**REGULAR MEETING OF THE
 ARAPAHOE COUNTY PLANNING COMMISSION
 TUESDAY, SEPTEMBER 20, 2016 AT 6:30 P.M.**

SUBJECT: Z16-003 – SKY RANCH, PRELIMINARY DEVELOPMENT PLAN AMENDMENT.	
P16-011 – SKY RANCH, PRELIMINARY PLAT.	
SHERMAN FEHER, PLANNER.	September 12, 2016

RE: Letter of Intent
Preliminary Plat and Preliminary Development Plan Amendment
Sky Ranch Subdivision
Arapahoe County Pre-submittal Case No. Q16-002

SHEET
5 OF 24
OVERALL
PRELIMINARY
DEVELOPMENT PLAN
EXHIBIT

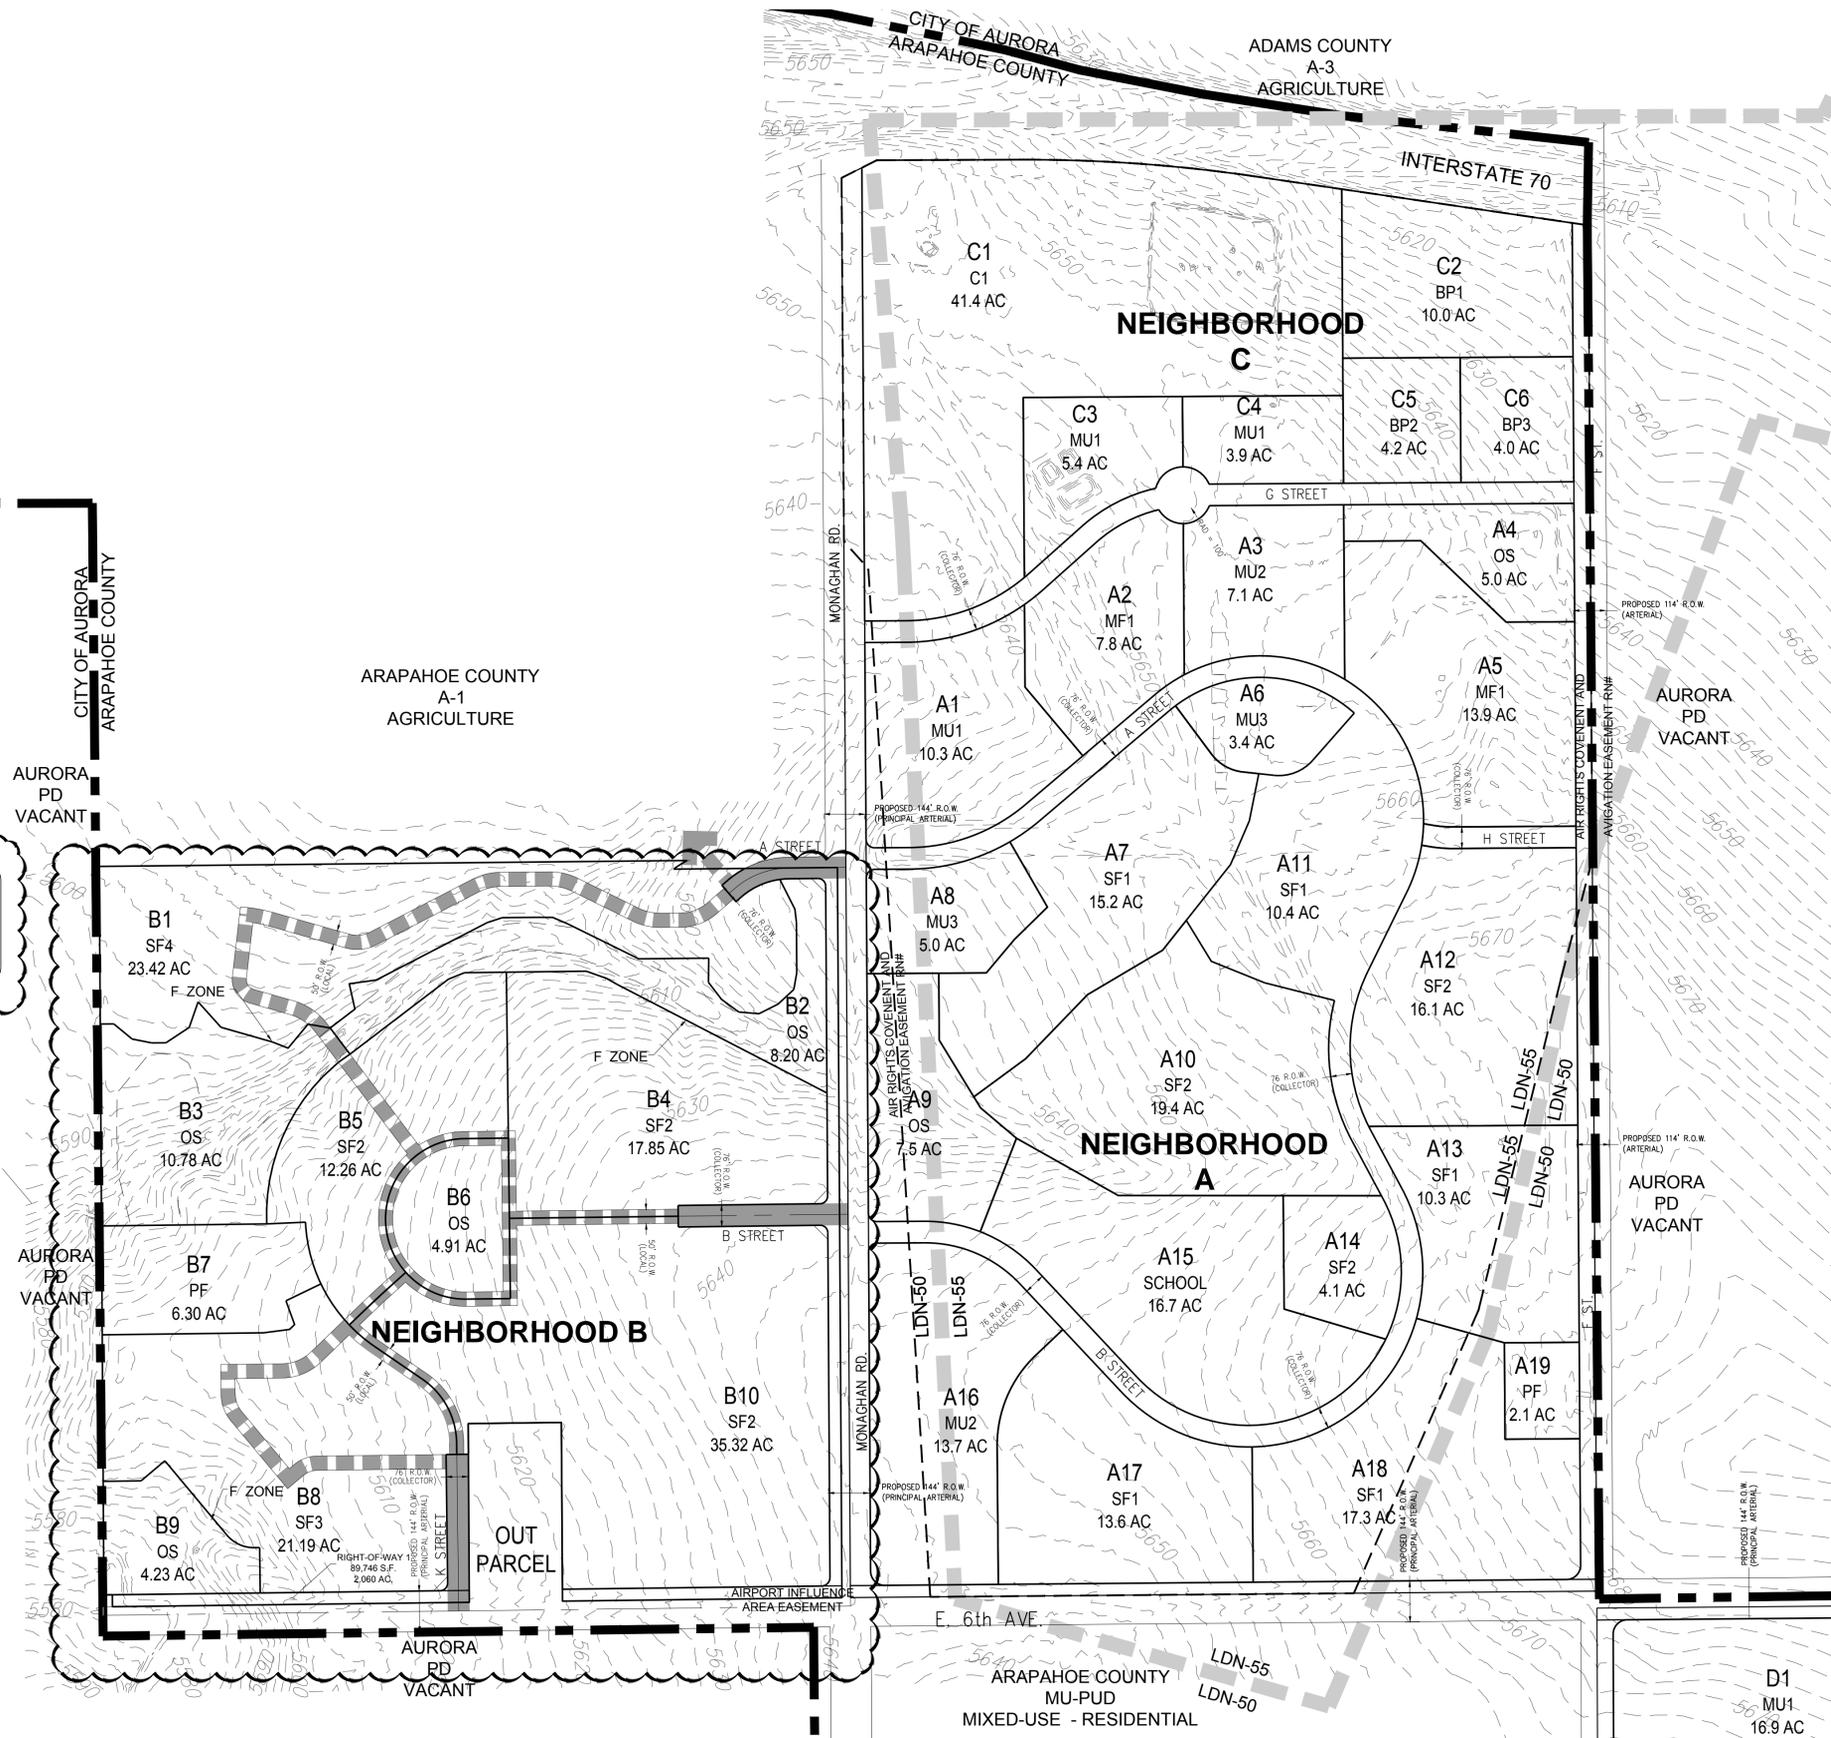
The "Residential Self-Imposed Limits" table on sheet 5 had a number of reallocations within the various neighborhoods, however the table was not outlined as changed. This will need to be done under the condition of approval that the applicant will make all minor modifications suggested by PWD Staff.

8. Comment: Please call out the source of the designation for one hundred-year floodplain of First Creek and Trib. T-9.
Response: First Creek's Floodplain is defined by FEMA Panel No.: 08005C0206L. The Trib T-9 source is defined by CVL's analysis, "Sky Ranch Floodplain Study", dated August 2016. A note to this effect has been added to Sheet 5 of 24 of the PDP.

NOTE:
1. FIRST CREEK'S FLOODPLAIN IS DEFINED BY FEMA PANEL NO. 08005C0206 L. THE TRIB T-9 SOURCE IS DEFINED BY CVL'S ANALYSIS. "SKY RANCH FLOODPLAIN STUDY", DATED AUGUST 2016

SHEET
6 OF 24
PRELIMINARY
DEVELOPMENT PLAN
EXHIBIT (NORTH
PORTION)
REPLACES SKY RANCH PDP, AMENDMENT NO. 1
CASE NUMBER A04-010, SHEET 4 OF 9
PDP AMENDMENT NO. 2

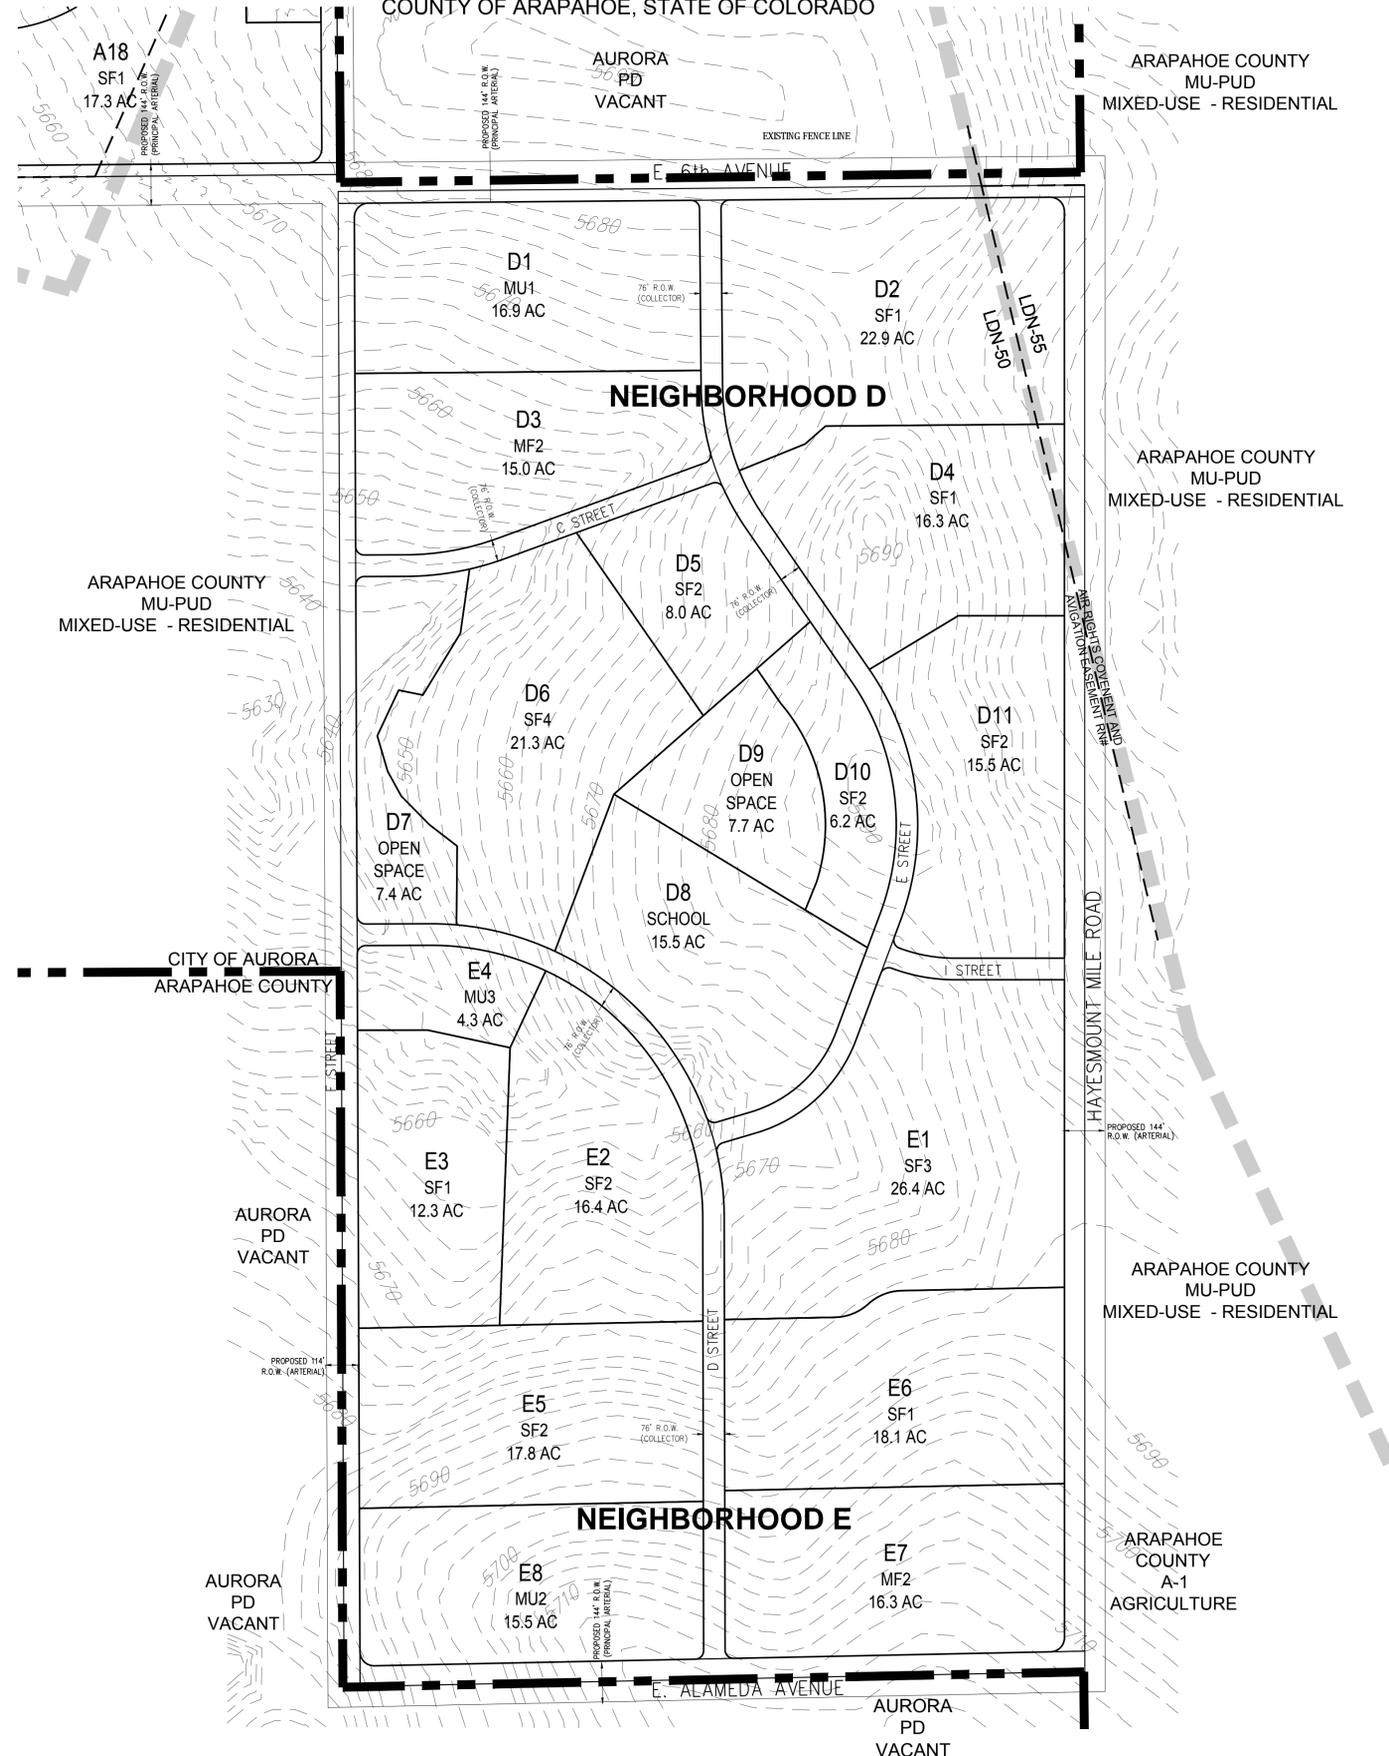
2. Comment: On Sheets 6 and 16 the F Zone is labeled. Is this the area that is being zoned floodplain? or the floodplain delineation itself. Please show and label the floodplain delineation as previously commented.

Response: *Completed. As discussed with the County, the F Zone designation will be applied to the tract areas (B2, B3, and B9). A floodplain and drainage easement is shown within the limits of those tracts, which includes the 100 year water surface plus freeboard. Please refer to the enhanced notes on sheet 3.*

SHEET
8 OF 24
PHASING PLAN

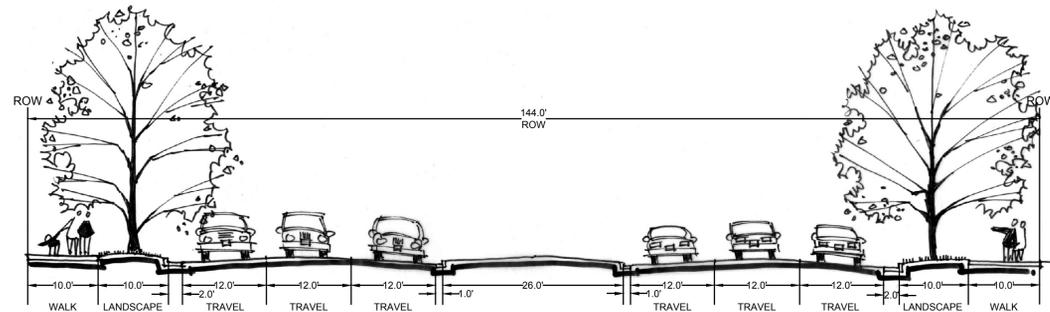
2. Comment: General Notes #6: the phasing map is on sheet 8 of 24, not 5 of 6. Please correct.

10. Comment: Sheet 8 of 24: show K Street on the plan and call out as such; and clearly define the roadway improvement limits.
Response: K Street has been added to the plans and the improvement limits are defined.
